Aman Winter Wears Ltd. (11333)

Nazimnagar, Hemayetpur, Savar.

09.June.2014

1st Priority 2 Concern

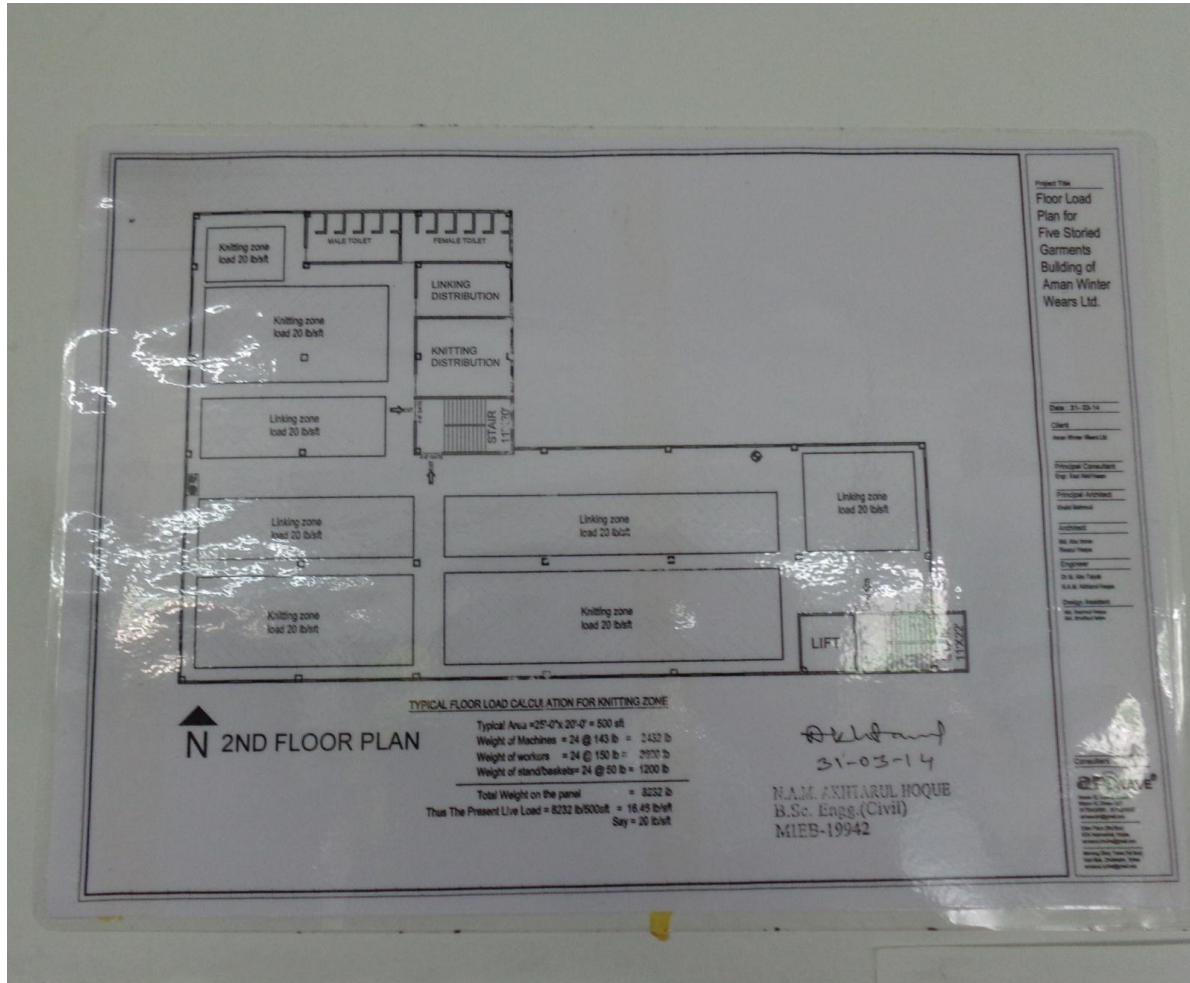
Poor steel detailing was observed for the various steel roofs. Poor connection bearing details were observed at the generator/ childcare/doctor's building (top left). Steel posts were bearing directly on the 3rd floor slab (top right). Poor bearing support and damaged masonry at generator shed (bottom left).

Item No.	Observation	Recommended Action Plan	Recommended Timeline
1	Priority 1 - Large washing machines were observed on the ground floor (structural due to presence of basement). In addition, a 6" platform was also observed in the same washing area.	A Detailed Engineering Assessment is required to determine load bearing capacity of ground floor in vicinity of washing platform and machines.	Immediate – Now
2	Priority 1 - Large washing machines were observed on the ground floor (structural due to presence of basement). In addition, a 6" platform was also observed in the same washing area.	Implement any recommendations from DEA.	6-weeks
3	1st Priority 2 - Poor steel detailing was observed for the various steel roofs.	Detailed Engineering Assessments are required for various steel roofs.	6-weeks
4	1st Priority 2 - Poor steel detailing was observed for the various steel roofs.	Implement any recommendations from DEAs.	6-months
